Re: Hallman Grove Subdivision
 Application #7-06004
 North Potomac, MD

**HALLMAN GROVE SUBDIVISION
COMMUNITY DENSITY ANALYSIS
12 AUGUST 2005**

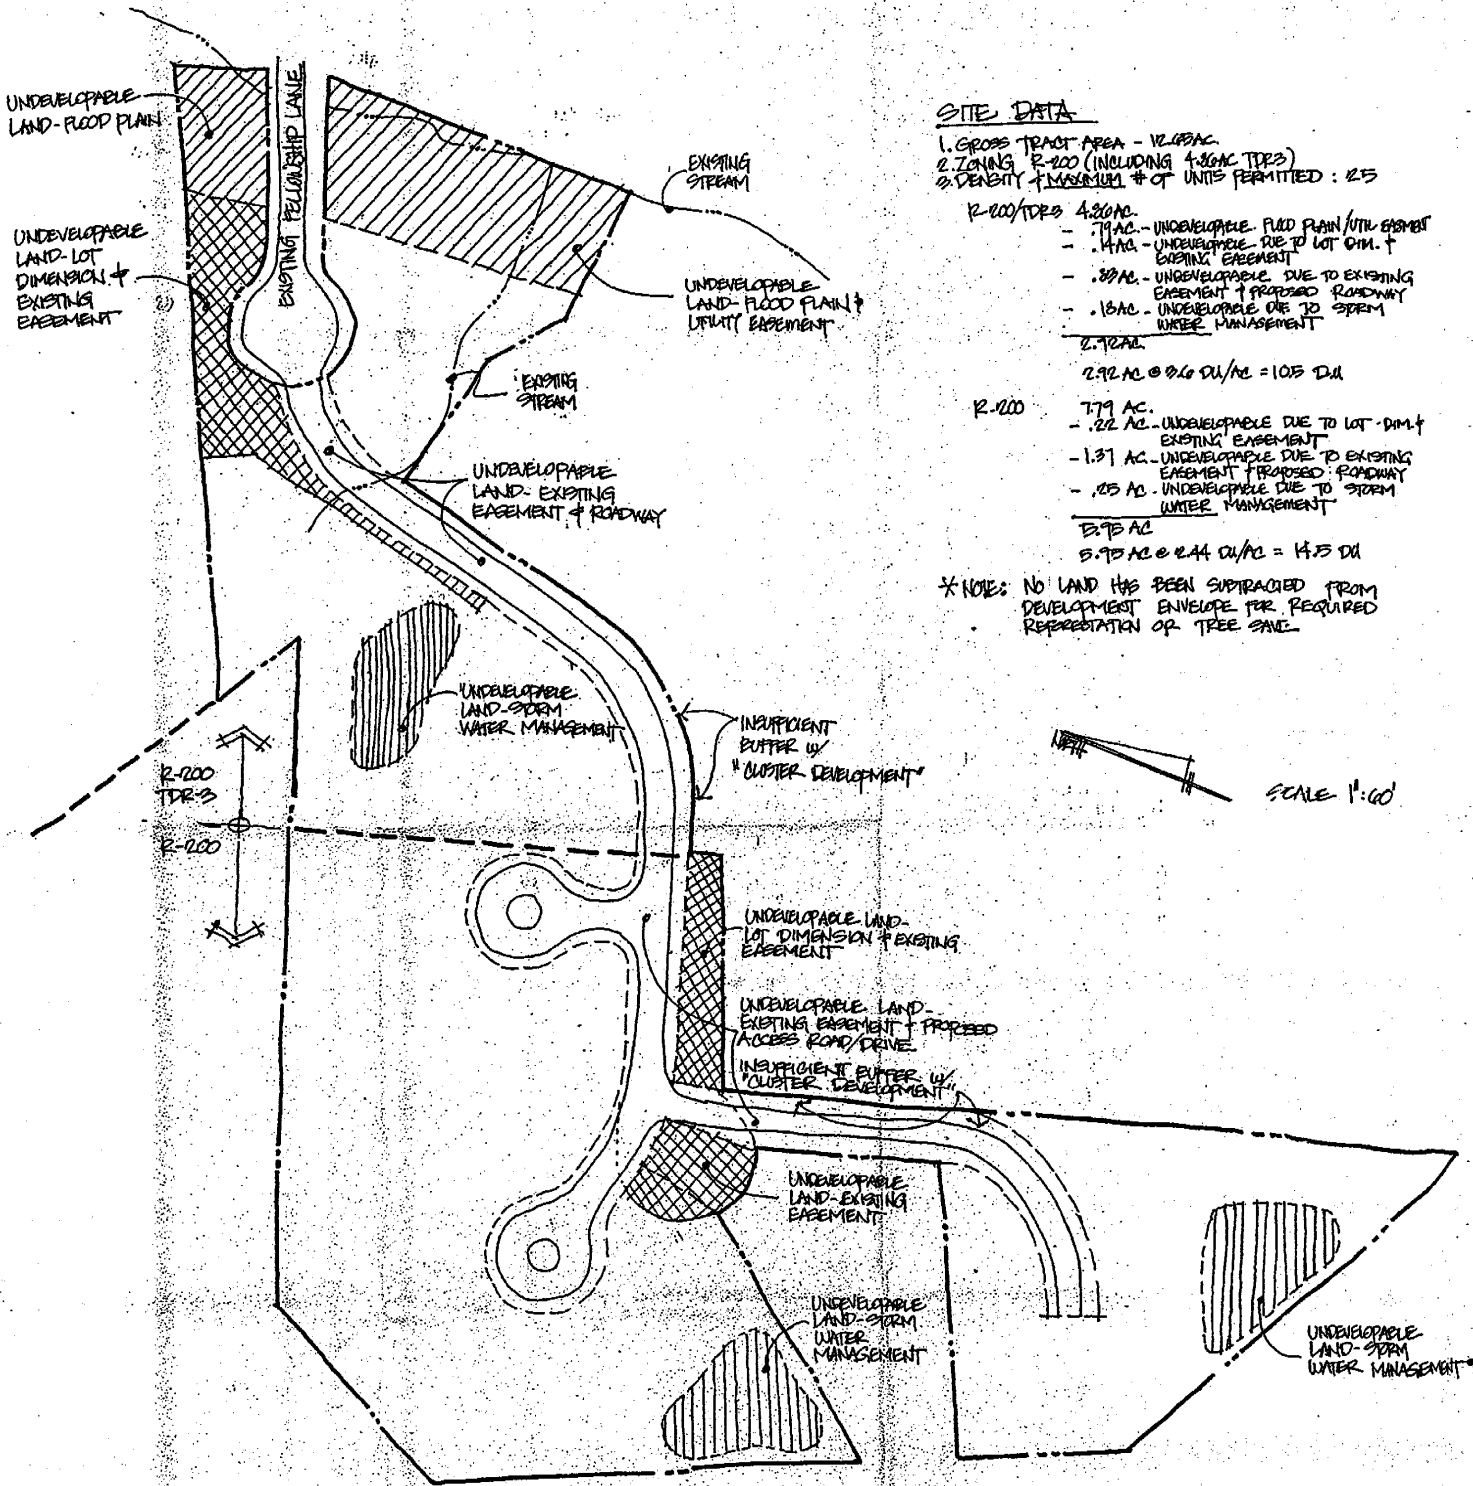
We have prepared the attached drawing and density calculations to highlight areas that must be subtracted from the total lot area to determine the maximum number of units that can be developed on this site. As you can see from our analysis, the developer has overstated the allowable density on the property by at least 11 dwelling units. Given the odd geometry of the tract of land and the many restrictions to development, we do not believe that more than 22 dwelling units could be developed without the implementation of a cluster concept. Further, the proposed development does not satisfy one of the key requirements of a cluster concept - the provision of additional buffers and green space for the community. Little or no buffer has been provided for the homes in Quince Orchard Estates which will back up to the proposed access road for the development.

- 1. GROSS TRACT AREA - 12.03 AC.
 - 2. ZONING R-200 (INCLUDING 4.36 AC TRS)
 - 3. DENSITY & MAXIMUM # OF UNITS PERMITTED : 25
- R-200/TRS 4.36 AC.**
- .71 AC - UNDEVELOPABLE - FLOOD PLAIN/UTR EASEMENT
 - .44 AC - UNDEVELOPABLE - DUE TO LOT DIM. & EXISTING EASEMENT
 - .89 AC - UNDEVELOPABLE - DUE TO EXISTING EASEMENT & PROPOSED ROADWAY
 - .18 AC - UNDEVELOPABLE - DUE TO STORM WATER MANAGEMENT
- 2.72 AC.**
- $2.92 AC @ 9.6 DU/AC = 105 DU$
- R-200**
- 7.79 AC.
 - .22 AC - UNDEVELOPABLE - DUE TO LOT DIM. & EXISTING EASEMENT
 - 1.37 AC - UNDEVELOPABLE - DUE TO EXISTING EASEMENT & PROPOSED ROADWAY
 - .25 AC - UNDEVELOPABLE - DUE TO STORM WATER MANAGEMENT
- 5.76 AC**
- $5.76 AC @ 2.44 DU/AC = 14.5 DU$

* NOTE: NO LAND HAS BEEN SUBTRACTED FROM DEVELOPMENT ENVELOPE FOR REQUIRED REGENERATION OR TREE SAVE.
